RFI

RFI #:
Date: 03/13/2024
Job: Erdman Cadillac – Cocoa, FL
PH:

RESPONSES TO RFI # 8 dated March 18, 2024:

ERDMAN CADILLAC - COCOA, FL
MECHO SHADE LOCATION AT CURTAIN WALL WITH
ATTACHED DETAIL INSTALLATION_3.18.24

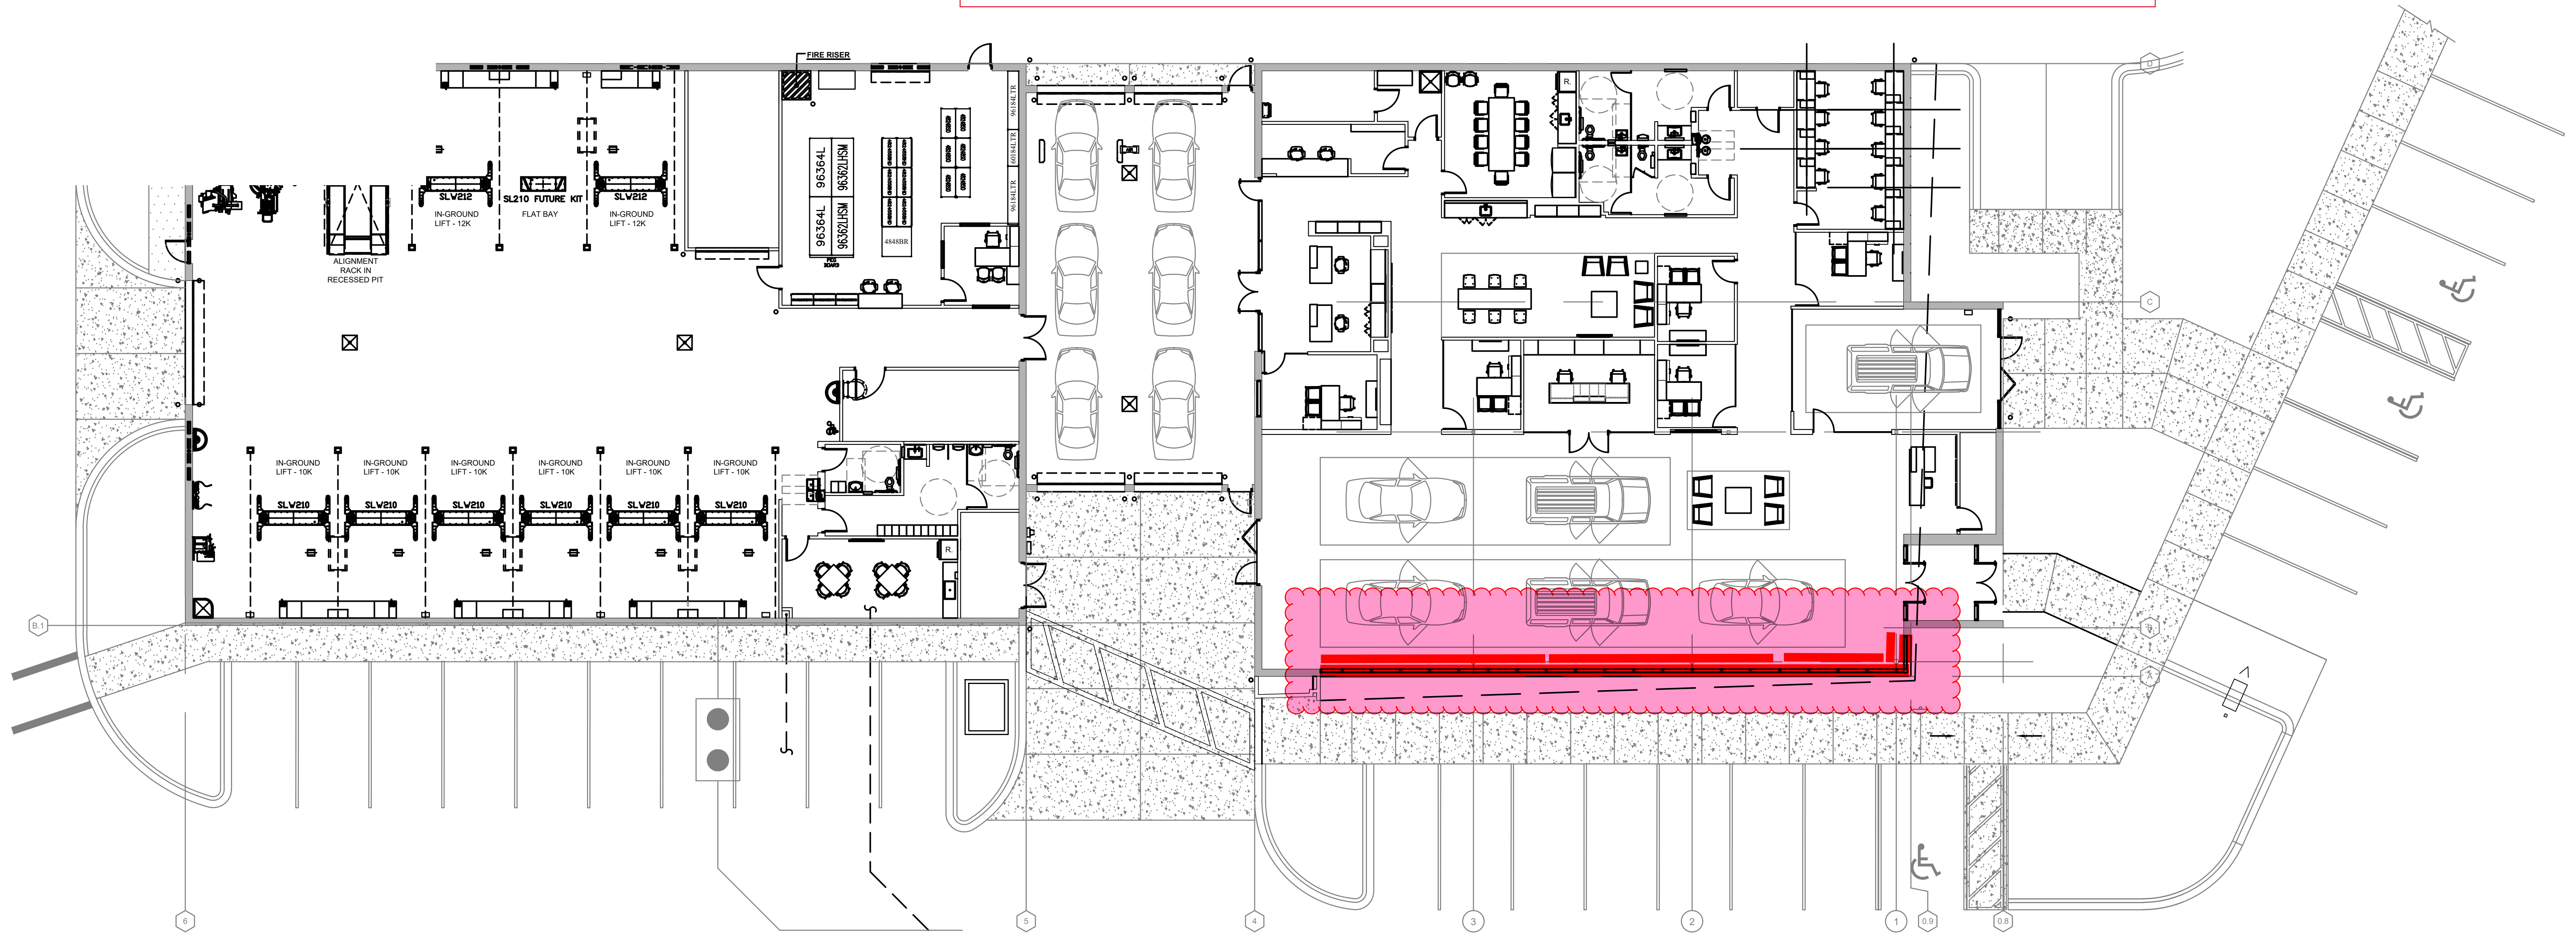
2. ID1.0 – The Finish Schedule indicates SH-1 Mechoshades; however, none were called-out on the Architectural or Electrical plans. Please confirm if the SH-1 Mechoshades are required, and if yes, please provide the locations and power requirements needed. **The Mecho Shades are required for the entire west / south curtain wall and will be furnished and installed by the Owner. The Mecho Shades will be remote controlled. The attached sheet shows the location of the Mecho Shades. The GC provides power to each section of Mecho Shade. Hartmann Architecture will issue a forthcoming Revised Power Plan indicating the power to the Mecho Shades.**
